Model: 23

No. 3

SUBJECT: ENGINE BREATHER LINE MODIFICATION

AIRCRAFT AFFECTED: M-1 through M-122.

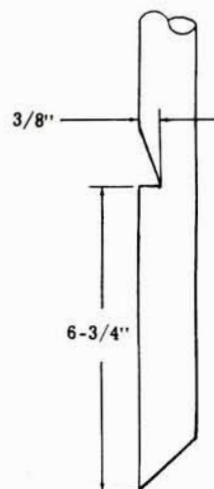
REASON FOR MODIFICATION: To prevent engine breather line stoppage due to freezing in extremely cold weather.

DESCRIPTION: To preclude the possibility of engine breather line stoppage in extremely cold weather, the following breather line modification is recommended on Model 23 Musketeers Serial M-1 through M-122.

Make a cut in the engine breather line, 6-3/4 inches up from the bottom of the tube and 3/8 inch deep as shown in the illustration.

The cut should be made on the forward side of the breather line in order to take advantage of the direct engine heat.

After the cut has been made, crimp the tube on the top side of the cut as illustrated.
